**BURGIN SUBDIVISION**

**KPB 2024-070**

**ITEM #4 - PRELIMINARY PLAT  
BURGIN SUBDIVISION**

<b>KPB File No.</b>	2024-070
<b>Plat Committee Meeting:</b>	June 22, 2024
<b>Applicant / Owner:</b>	Burgin and Ray Trust Dated October 22, 2007 / Anchorage, Alaska
<b>Surveyor:</b>	Mark Aimonetti / Edge Survey and Design, LLC
<b>General Location:</b>	Sterling Highway and Wildrose Lane, Ninilchik

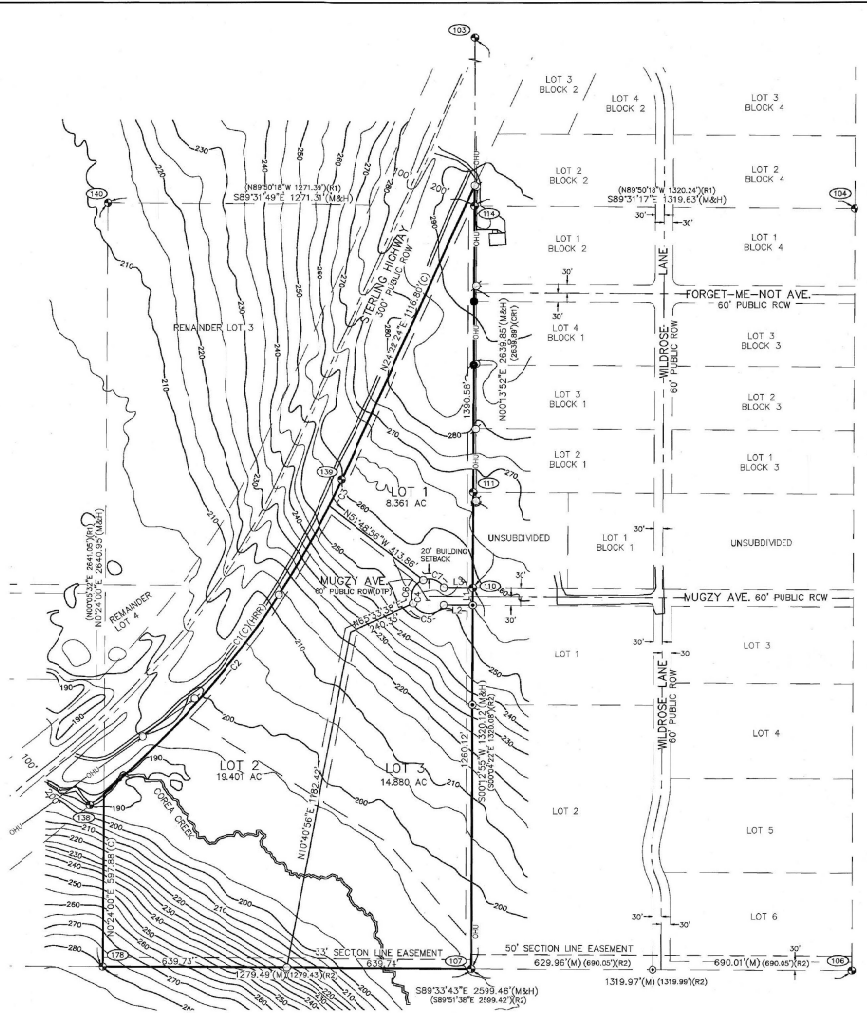
There are steep areas as shown by the contours on the plat. They should be clearly indicated as being steep on the final plat with a label of “steep” and direction of the slope. The contours can be removed for the final plat submittal.

Wetlands are also crossing the plat, coinciding with the low area of Corea Creek. The wetlands should be shown on the final and plat note 5 should remain on the final as well. The River Center review did not indicate the plat to be in a FEMA designated floodplain or flood hazard zone. Plat note 6 should be verified with the River Center, and if not applicable, should be removed.

- In the legend, the lines for 20' building setback and overhead utility line need changed to represent the correct line being used. Check others for correctness also as it appears interior lot line, edge of gravel, and bank of creek may be the same.
- Verify the use of (R3) as it appears to be missing from the plat. If it is not used,
- Add the date of July 22, 2024 to plat note 3.
- Add distance and bearing from the SW1/16 to the north point of subdivision.
- Verify details of monuments 110 and 111.
- Additional items as outlined below.

- Staff recommendation:**  
Adjust legal description to include that part of Government Lot 2 lying south of the Sterling Highway as there is part above the CW1/16 marker.  
Add the KPB Number 2024-070.

- Staff recommendation:**  
Darken the section line on the vicinity map  
Label and show Wildrose Ln and Mugzy Ave on the east  
Label Corea Creek  
Label section 12

- Staff recommendation:**  
33' section line easement needs shown on the southwest line of the subdivision.
- G. The status of adjacent lands within 100 feet of the proposed subdivision boundary or the land status across from any dedicated rights-of-way that adjoin the propose subdivision boundary, including names of subdivisions, lot lines, block numbers, lot numbers, rights-of-way; or an indication that the adjacent land is not subdivided;

- Staff recommendation:**  
Plat identifiers need added to the east  
Government lots need labeled to the north and south.

Unsubdivided parcels needed labeled o the southeast and southwest.  
Adjust 20' setback and OHU in legend  
Verify interior lot line, edge of gravel, and bank of creek are different in legend

- H. Approximate locations of low wet areas, areas subject to inundation, areas subject to flooding or storm water overflow, and the line of ordinary high water. This information may be provided on an additional sheet if showing these areas causes the preliminary plat to appear cluttered and/or difficult to read;  
**Staff recommendation:**  
Low wet areas need shown and identified on the plat
- M. Approximate locations of slopes over 20 percent in grade and if contours are shown, the areas of the contours that exceed 20 percent grade shall be clearly labeled as such;  
**Staff recommendation:**  
Label steep areas on the plat

- Staff recommendation:** comply with 20.60.190.  
Add “and public areas to public use” after “rights-of-way” in the Certificate of Ownership  
Add Certificate for Acceptance  
Update date in Plat Approval to July 22, 2024

- Staff recommendation:** comply with 20.60.200  
Add details for found monuments of record in the legend  
Verify monuments 110 and 111 for accuracy as they appear the same in detail

**BURGIN SUBDIVISION**

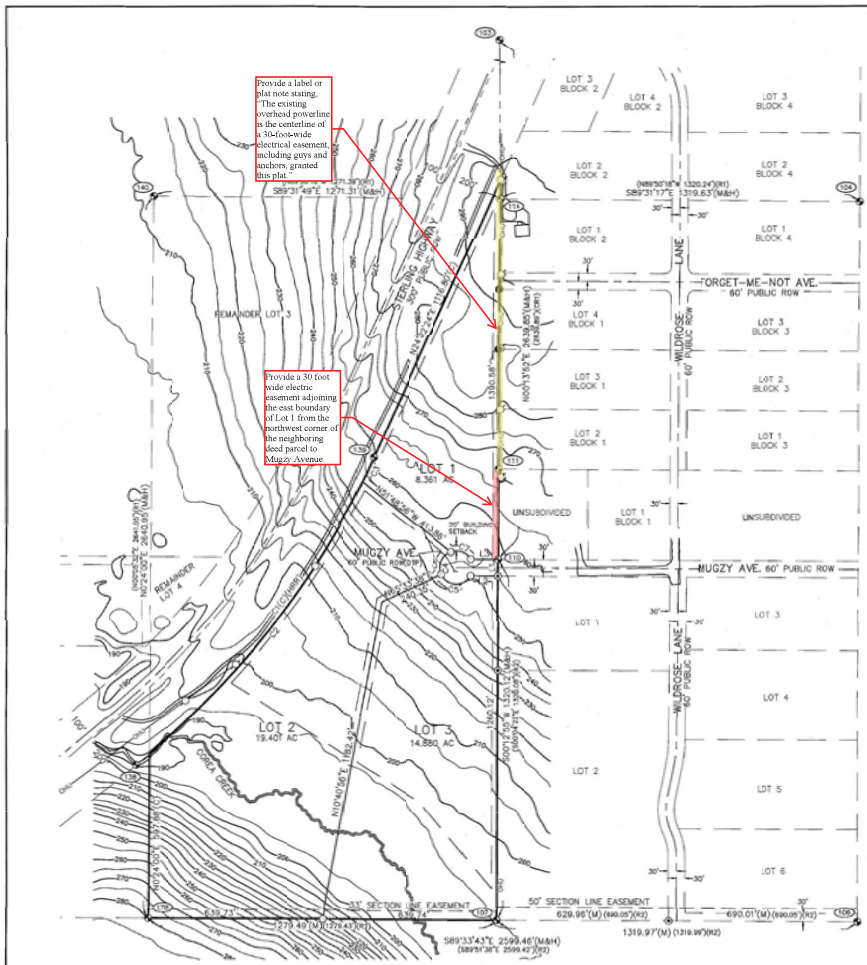
Provide a label or plot note stating: "The existing overhead powerline is the centerline of a 30-foot-wide electrical easement including guys and anchors, granted this plan."

Provide a 30-foot wide electric easement adjoining the east boundary of Lot 1 from the northwest corner of the neighboring block parcel to Mugzy Avenue.
